## Product Change Notification

Product Change Notification Number: PDF-032

<b>Title: Manufacturing Capacity Expansion for the 8-contact, 6 x 8mm, Very Thin Dual Flat No Lead Package (VDFN)</b>			
<b>Product Identification:</b> Specific Adesto products offered in the 6x8 mm VDFN package (part number package suffix 'MW'). See Table I for a complete list of affected Adesto part numbers.			
Reason For Change	<input checked="" type="checkbox"/> Capacity Expansion	<input checked="" type="checkbox"/> Design	<input checked="" type="checkbox"/> Manufacturing Location
	<input type="checkbox"/> Material / Composition	<input type="checkbox"/> Processing/Manufacturing	<input type="checkbox"/> Quality & Reliability
<b>Change Description:</b> Addition of a qualified subcontractor for assembly and final electrical test services for products offered in the VDFN 6x8 mm package selection to further expand capacity.  <i>NO external package dimensional changes, that would affect PCB board layout or device functionality, occur with this change (see Figure 1 for package thermal pad dimensions).</i>

**FIGURE 1 PACKAGE DIMENSIONAL CHANGES (published datasheet updated)**

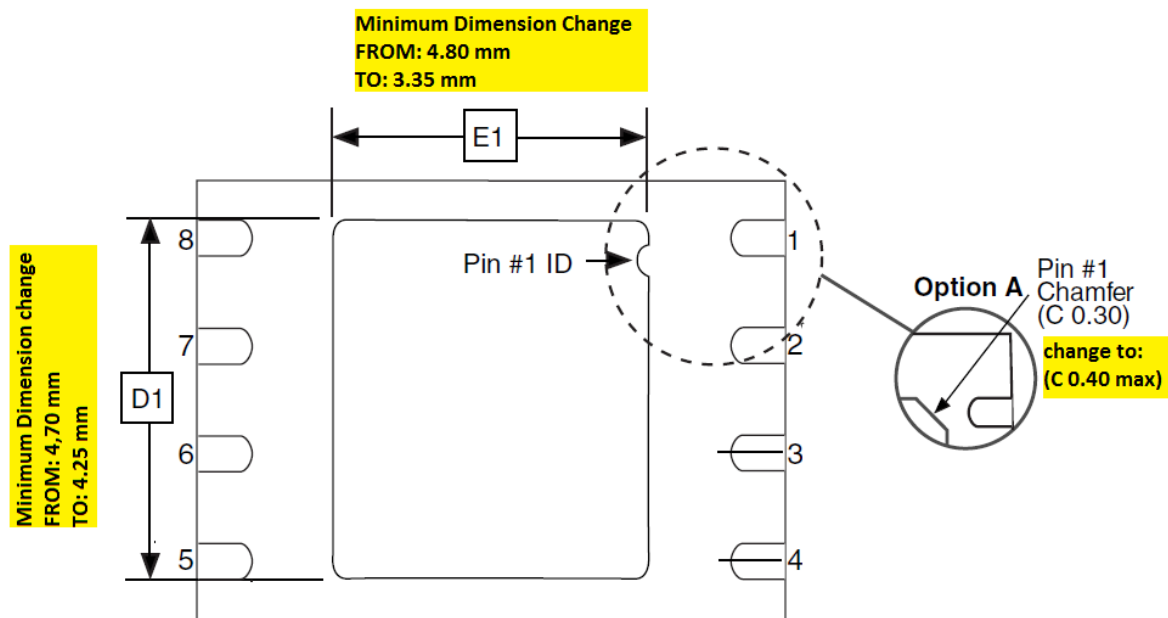
NO critical external package dimensional changes.

The minimum dimensions of the thermal pad have reduced as shown below.

Impact to board layout: NONE

These changes have no impact on board layout due to industry standard recommendation not to run PCB traces under the pad area.
